**ENRICO FERMI ATOMIC POWER PLANT
UNIT NO. 2
EVALUATION OF
CONTAINMENT COATINGS**

EVALUATION OF
CONTAINMENT COATINGS

REPORT NO. DECO-12-2191
REVISION 4

RESPONSES TO NRC QUESTIONS
"PRIMARY CONTAINMENT COATINGS EVALUATIONS"

FIGURE 1

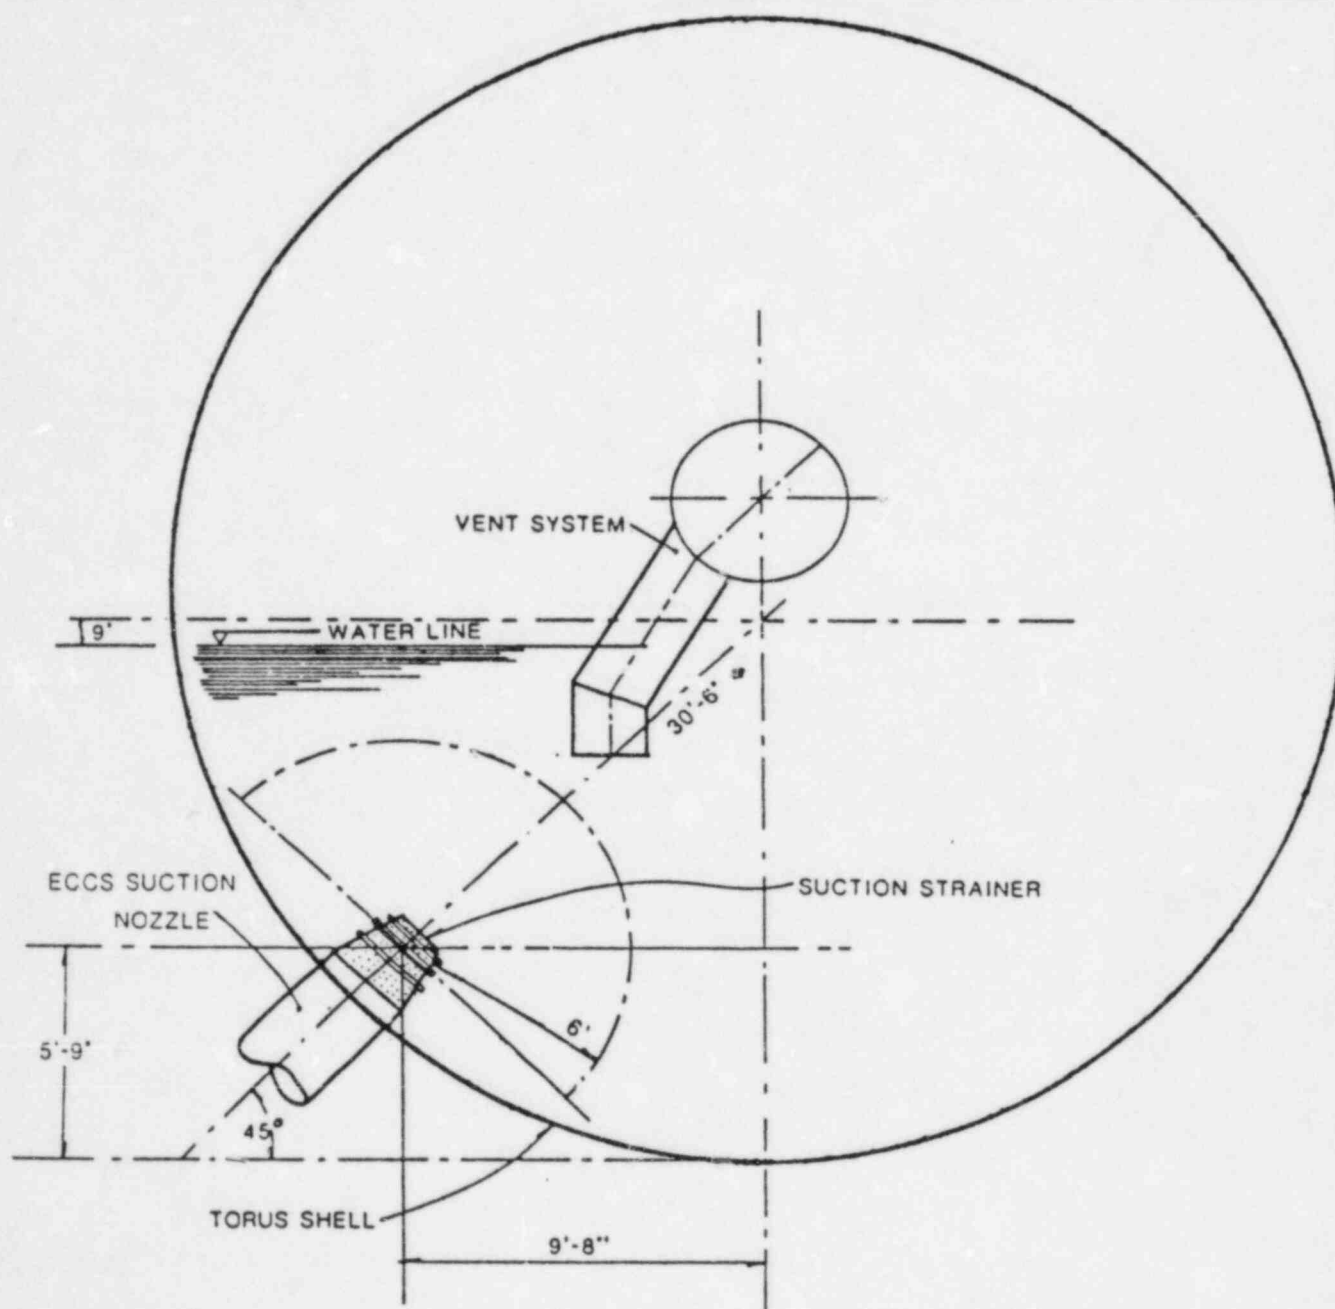
- (e) The debris concentrations are ingested into the ECCS flow and are circulated through the ECCS flow path.
3. Provide the data, or your analysis, which you used to arrive at the following statement on Page 18 "... average water velocities within the torus following the initial transient are below 0.25 ft/sec, but approach 0.3 ft/sec within a 4 foot hemisphere..."

4. Indicate what the velocities would be in the torus pool following the initial transient if the safety relief valves were to discharge or the automatic depressurization system were to be activated. State the effect that such a valve discharge would do to paint particulates into the emergency core cooling system (ECCS) recirculation trains would occur. Provide your calculations or data, to support your conclusions on this matter.

RESPONSE: See response to Question 2 above.

RESPONSE: See response to Question 2 above.
